FAIRVIEW FARMS GOLF COURSE

Harwinton, Connecticut

King's Mark Environmental Review Team Report

February 1998

Draft Proposed Project Plan

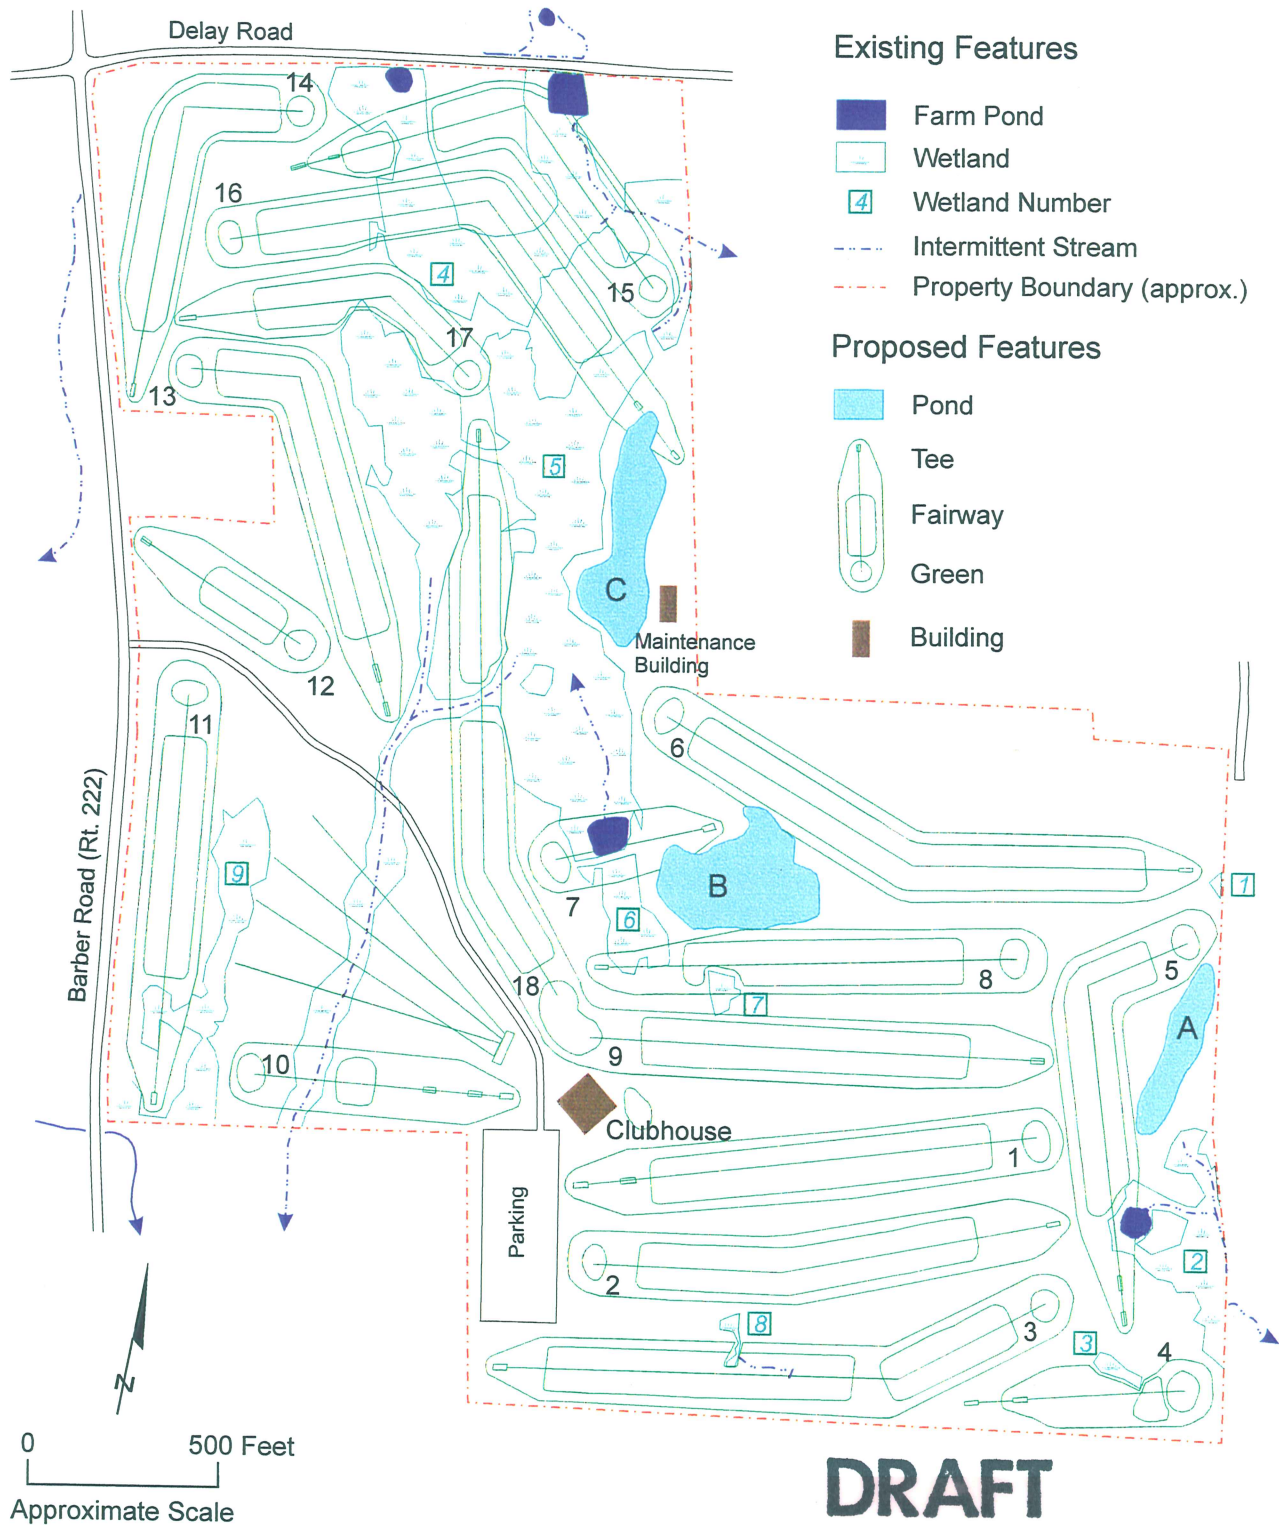
9. Proposed pond spillways should be indicated on the plan. The applicant should also provide information to the HIWWC to demonstrate the stability of these areas, as well as areas downstream of the spillways, during high flow periods.

10. Two areas of proposed wetland impacts have not been indicated on the 1"=100' plans. The first is an area between the 15th hole and the 16th tee which, according to the 1"=40' plans will be filled. The second is a small area of wetlands on the east edge of the 18th tee which has not been indicated as being disturbed on the 1"-100' plan. Additionally, it is recommended to include those areas proposed for irrigation lines which appear to be in wetland areas as areas of temporary impact.

1. A "Limit of Disturbance" line should be included on the site plans. It is not clear from the current plans as to where construction activity will be allowed and where it will not occur.

2. Diversions and other sediment and erosion control measures should be indicated on the site plans. This information should be clearly illustrated for ease of reference, proper installation, proper control of erosion which is likely to occur on an exposed soil, and to insure that wetland areas are protected. Sediment and erosion control notes which are included in the "Draft Environmental Report: Fairview Farms Golf Course" should also be included in the site plans in narrative form.

4. Hole #4: E&S control measures should be illustrated on the site plans as protecting the local wetland at hole #4.
5. Hole #5: No E&S control measures are shown for this hole. As designed, the hole will cut into the existing wetland and pond. Is it possible to move the tee area north to remove any impact to the pond or wetland? If not, silt fence or other sediment and erosion control measures should be installed to protect the remaining wetlands and indicated on the site plans.

6. Hole #6: Silt fencing or other E&S control measures should be installed at the bottom of this proposed hole, as a small wetland exists just below the tee area.

7. Hole #7: There did not appear to be any detailed site plans (1:40 scale) for this hole. No sediment and erosion control measures are shown despite plans to construct the hole in the central wetland corridor. A detailed drawing depicting proper E&S controls should be made.

8. Hole #8: No sediment and erosion control measures are indicated as protecting the wetland which exists between the proposed hole #8 and hole #9. Silt fence or other control measures should be indicated. Additionally, no sediment or erosion control measures are indicated as protecting the wetland located adjacent to the proposed tee area. Is it possible to shorten the tee area to begin north of the central wetland area?

9. Hole #10: There are no E&S measures currently illustrated on the site plans. E&S control measures should be illustrated on the plans to protect the central wetland corridor.

10. Hole #11: E&S measures should be indicated as protecting the area adjacent to the impacted wetland and any areas upslope of the adjacent wetland.

11. Hole #15: Additional silt fence is needed around the construction area perimeter. As depicted on the 1:40 plans (sheet 1), the fairway edge is currently outside of the silt fence. The silt fence should be shown exterior to the work area. Additional silt fence is also needed to prevent silts from entering the wetland area between hole #15 and #16. Extending the existing fencing would accomplish this.

12. Hole # 16: Additional silt fence is necessary to sufficiently protect the adjacent wetlands. Why does the silt fence terminate when it should continue? The silt fence needs to be extended to provide complete coverage of the central wetland corridor. The proposed tee area should also have sediment controls along both its northern and

southern edge. The tee area clearly cuts through wetland areas, yet no E&S control measures are shown.

13. Hole #18: This proposed fairway sits adjacent to the central wetland corridor, yet sediment control measures are minimal. Silt fence should be installed around the perimeter of the work area, as it sits between two wetland areas.

1. Proposed "pond B": As presently designed, the perimeter of "pond B" overlaps the perimeters of hole #6 and hole #7. Clarification should be made as to whether the pond will be redesigned to not impact these two fairways or if the fairway perimeters will be

redesigned to conform to the shape of the proposed pond. In either case, the correction should be detailed in the plans.

2. Sheet no. 2 depicts proposed "pond B" and proposed "pond C," apparently adjacent to one another, while on the 1:100 scale map, they are several hundred feet away. It appears that the location of "pond B" and "pond C" have been shown together to illustrate detail, but this is not indicated on the map nor should it assumed to be the case. Clarification should be made and the site plans adjusted accordingly.

3. Sheet no. 2: It is unclear as to the location of the spoils areas which are indicated on this sketch. Do the two spoils area correspond with proposed "pond B," or, with proposed "pond C?" Clarification should be made. It would be helpful if the "spoils areas" were indicated on the 1:100 scale map.

1. Whereas the wetland areas are defined in the field and indicated on the overall site map, none of the wetlands, watercourses, or existing ponds are identified with a buffer zone. Buffer zones are critical to the protection of wetland ecosystems and streams and are used to identify the area in which activity should be regulated. With this information, the commission and all interested parties would be better able to understand the extent of the proposed development and the potential impacts.

2. An example of where this information would be beneficial is hole #3, where a perennial stream exists midway along the fairway. No buffer is indicated on the site plans. It appears then that construction activity could occur at any point along the stream with no sediment and erosion controls in place. Additionally, there is no documentation in the plans as to the sediment and erosion control measures which

will be installed for this stream or the wetland area of hole #3 (1:40 scale plans are provided for the other areas which are impacted).

3. Due to the proposed land grading and construction of hole #7 and hole #8, the wetland area located between the two will become isolated. By isolating this wetland area, it is likely that the level or hydraulic recharge to the soil will diminish, resulting in a degradation to the wetland. As such, additional "wetlands" not accounted for may be lost.

4. Holes #15 and #16: The grading of land in this area will effectively bisect a portion of the central wetland corridor (in an "upper" and "lower" location). The remaining wetland soils located between these two holes will become isolated from the central wetland corridor, save a culvert which is to be installed under hole #16. While it is difficult to determine to what extent, it is likely that the remaining wetland hydrology will be altered and possibly become drier than it's current state.

2. It may be possible to minimize the impact along the central wetland corridor by modifying the current proposal. It may be possible to skew the run of hole #6 more towards the northerly property boundary, adjusting the angle of the hole to maintain the dogleg effect. If so, this would result in an increased space between holes #6 and #8. With this modification, it may be possible to move hole #7 out of the central wetland corridor and relocate it between holes #6 and #8. The location of proposed "pond B"
